October 12, 1983

Subject: Construction Assessment Inspection of Palo Verde Unit 1

The objective was to provide an overall assessment of the actual as-built condition of the Palo Verde Nuclear Generating Station Unit 1 (PVNGS-1) by comparing the as-built condition to design requirements. Therefore, the inspection concentrated on hardware and assessed whether the construction of PVNGS-1 was performed in accordance with quality requirements applicable to the plant.

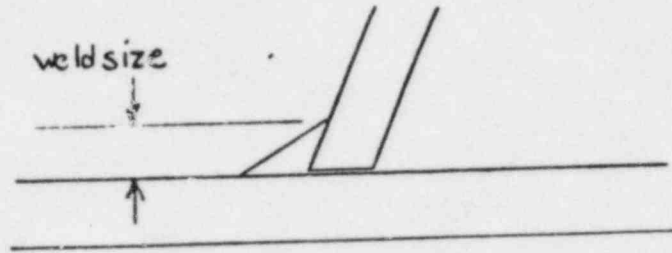
Support SI-100-H005 was found with an underfill condition in the stanchion, Item 30, to pipe weld. The weld is required to be a 5/16-inch fillet weld. The actual fill was measured to be 1/4 inch. The weld was accepted on the field weld check list on November 9, 1981.

The AWS D.1.1 Code 1974 shows, in Figure 2.7.1, that skewed fillet welds are measured thus:

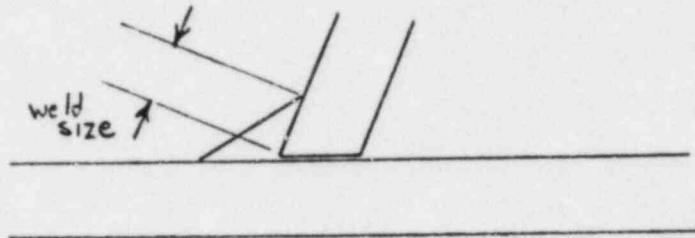
At Palo Verde the QC Engineer states weld are "measured" as shown below (it is not clear how this is "measured" since there is no access to one of the measurement points):

To "measure" by the Palo Verde method to a given size (e.g., 5/16 inch on a 120-degree weld) will result in an undersize weld by the Code definition (in this case by 3/64 inch). Nonetheless, QC inspectors are required by WPP/QCI 201.1 to inspect to AWS D.1.1 criteria for this weld. The AWS D.1.1 criteria are clear and are not superceded by verbal instructions from engineering.

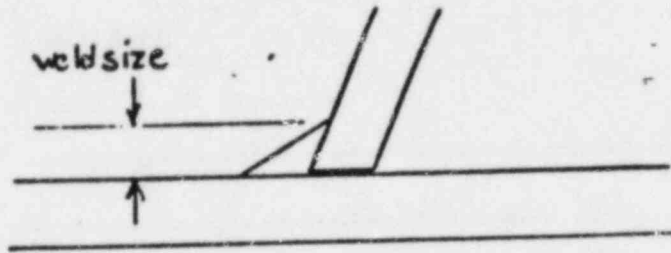
Support SI-100-H005 was found with an underfill condition in the stanchion, Item 30, to pipe weld. The weld is required to be a 5/16-inch fillet weld. The actual fill was measured to be 1/4 inch. The weld was accepted on the field weld check list on November 9, 1981.

The AWS D.1.1 Code 1974 shows, in Figure 2.7.1, that skewed fillet welds are measured thus:

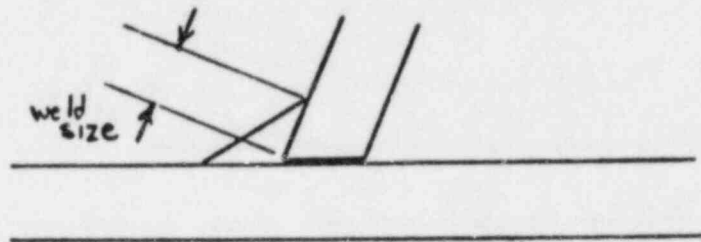
At Palo Verde the QC Engineer states weld are "measured" as shown below (it is not clear how this is "measured" since there is no access to one of the measurement points):

To "measure" by the Palo Verde method to a given size (e.g., 5/16 inch on a 120-degree weld) will result in an undersize weld by the Code definition (in this case by 3/64 inch). Nonetheless, QC inspectors are required by WPP/QCI 201.1 to inspect to AWS D.1.1 criteria for this weld. The AWS D.1.1 criteria are clear and are not superceded by verbal instructions from engineering.
